NOTICE OF A TYPE I DECISION ON A PROPOSAL IN YOUR NEIGHBORHOOD

CASE FILE NUMBER: LU 14-122929 HR – BASEMENT WINDOW

Proposal: The applicant has proposed to replace and enlarge a single street-facing basement window on the north/Holly Street-facing side of the home at 1609 SE 16th Avenue. The existing basement window on the north façade just east of the brick chimney would be removed and replaced with a new metal clad wood casement window (Marvin Clad Ultimate Casement) measuring 2'-2" wide by 3'-8" tall. The window would be surrounded by 0'-4¼"-wide painted wood trim. The new window would be surrounded by a new 0'-6"-wide concrete window well wall, located 3'-0" out from the building wall, and with a 2'-0" deep well a minimum of 3'-6" wide around the enlarged window opening. Alterations to basement windows on a street-facing wall in Historic Districts requires Historic Review (33.445.320.A.1). Because the alteration affects less than 150 square feet of the façade in an R5 zone, the request is handled through the Type I procedure (33.846.060.B.4).

SITE PLAN

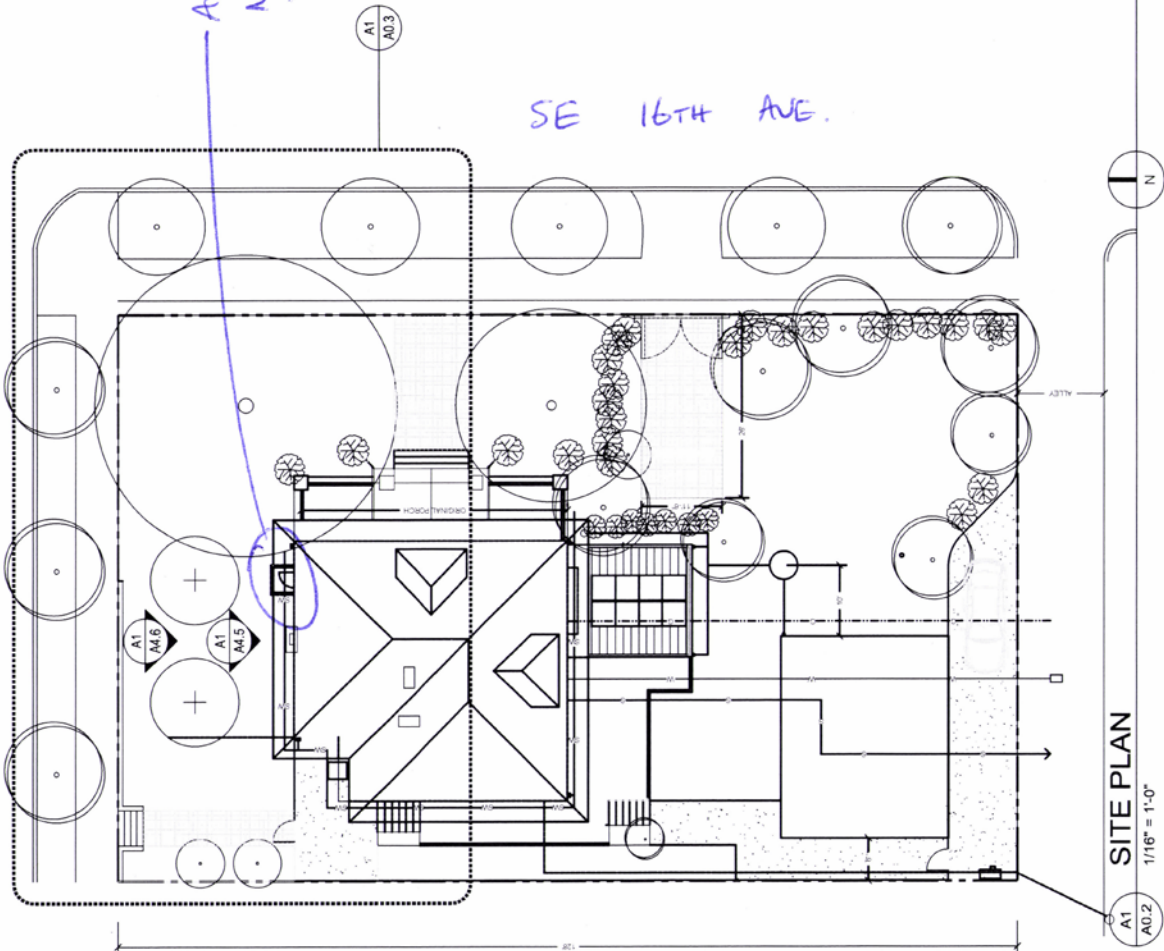
Basement egress windows on the two non-street facing facades are not an option because the applicant has installed a wrapping above-grade deck onto those two sides of the home, covering up the original basement foundation walls on those facades. Basement windows on the two non-street-facing facades could have been exempt from Historic Resource Review (33.445.320.B.4), but that is not an option unless the above-grade deck is reduced in size by the applicant. Foreclosing the use of non-street facades for new basement egress by installing raised decks or situating mechanical or utility rooms against other potential window opening locations in the basement does not justify installing them on a street-facing façade.

The applicant has proposed a new street-facing basement egress window and excavated concrete window well on a contributing home at SE 16th & Holly in Ladd's Addition. A review in the recent past approved a large deck on the south side of the home facing the alley, and an existing wrap-around deck was retained on the rear of the home. Internal reconfiguration of the basement rooms and uses has precluded installation of a new egress window on the west/rear façade, as well. For these reasons, the option to install basement egress windows on a non-street facing façade through an Historic Review exemption has been voluntarily precluded by the applicant in their remodeling plans. The proposed alternative location for an egress window on the Holly-facing street façade cannot meet the

1
A4.5
EXTERIOR ELEVATION - NORTH
3/16" = 1'-0"

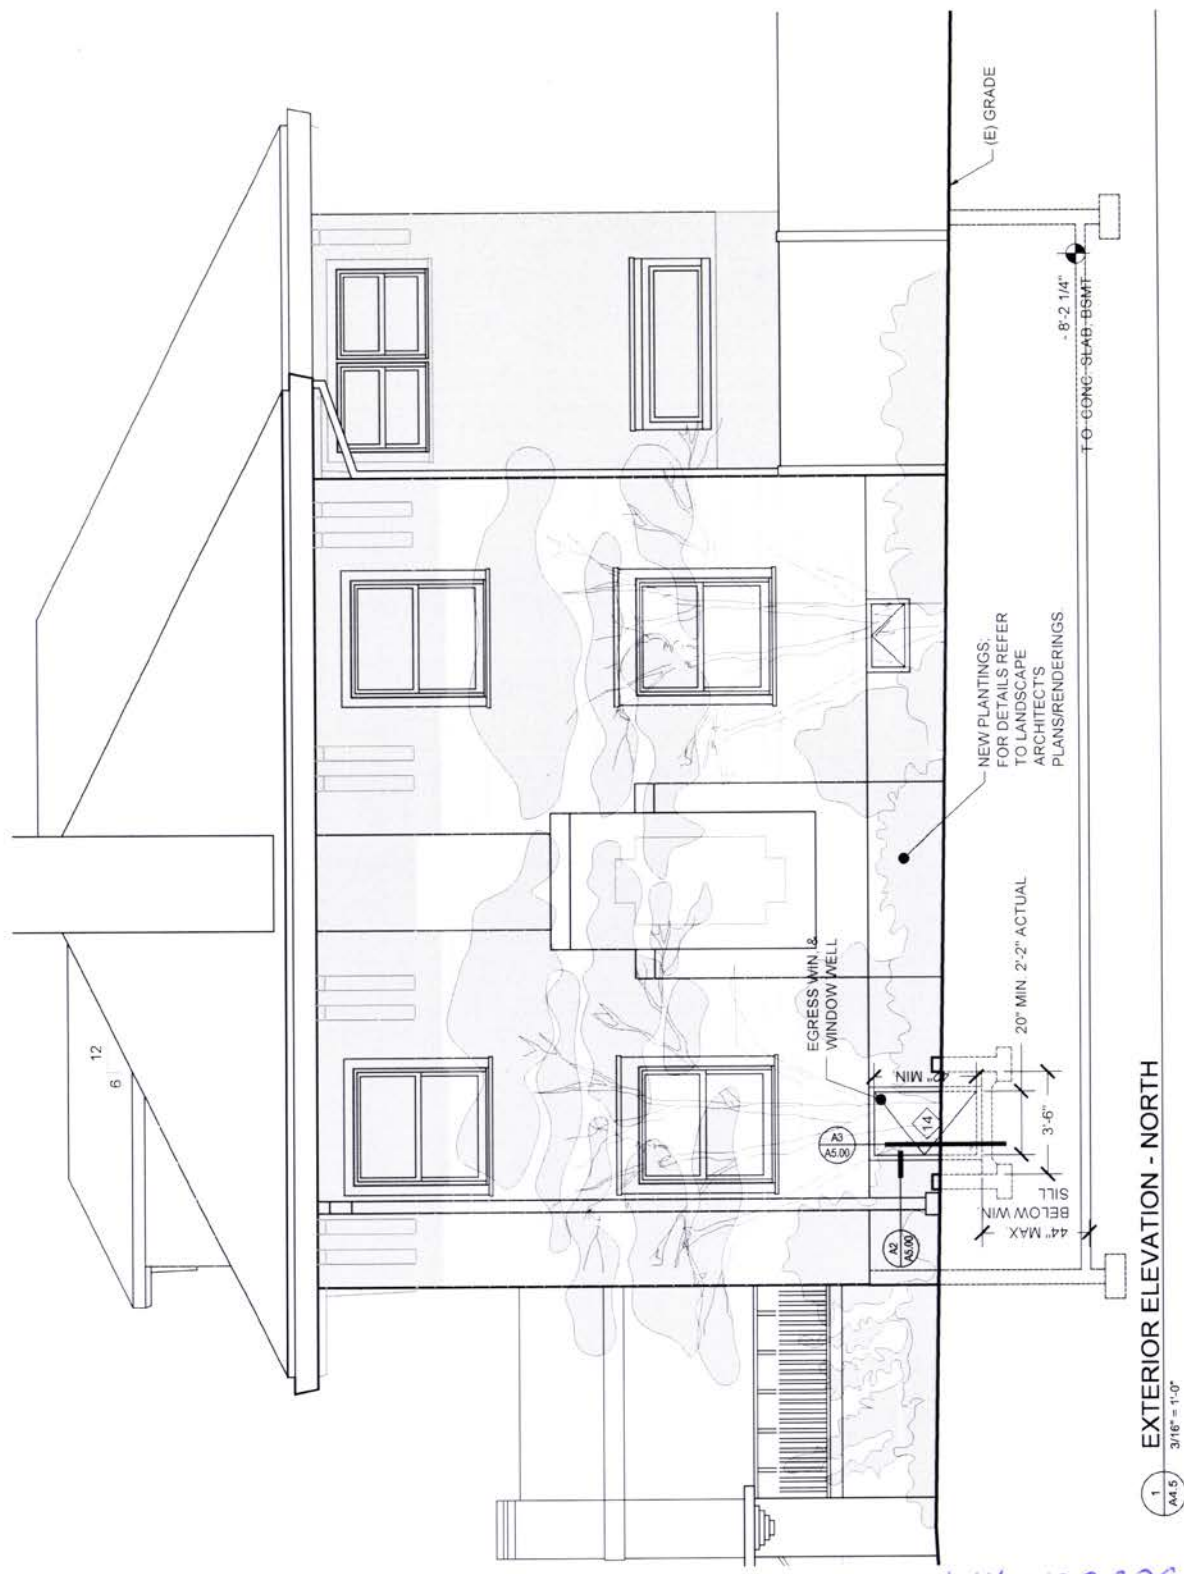
Findings: The proposal is for a single new basement egress window on the north side street-facing façade oriented towards SE Holly Street. This façade is one of two street-facing facades on the home. The applicant argues that the new window is “minimally invasive and will match the windows on the rest of the house. Based on utility locations and deck, this is the only feasible location for a bedroom with legal egress in the lower level of the house” (Exhibit A.1).

The north street façade has a primary façade closest to the street, and a secondary street-facing façade somewhat further back from the street on the west/rear side of the home. The primary façade has a symmetrical composition with a central chimney with decorative stucco panel, and paired identical windows on each side of the chimney at both main floors and at the basement. The existing basement windows are of the same size, measuring approximately 2'-6" wide by 1'-6" tall. The easterly of these two windows would be removed along with adjacent portions of the wall to create a new window opening measuring 2'-2" wide by 3'-8" tall. New below-grade excavations are necessary for the installation of the new basement window, resulting in new concrete retaining walls which would be visible adjacent to the new window and from the street.

The proposal does not maintain the integrity of the existing street-facing façade by altering the size and scale of historic window openings on the façade of this contributing structure. The symmetrical pattern of window openings is broken by the installation of the larger window with mismatched sash and trim details, disrupting the architectural integrity of the facade.

Findings: The original windows for the basement on the north façade are in place. However, the most recent land use review at the site approved the replacement of all original windows due to deterioration of original material. The proposed new basement window is not compatible with the original window opening in terms of form, size and placement. The new window is of a size that requires excavation for a new window well with exposed concrete retaining walls on a street-facing façade. The new window does not match the original window, and is not compatible with the symmetrical façade composition on the north/Holly Street elevation. *Therefore, this guideline is not met.*

Therefore, this guideline is not met.
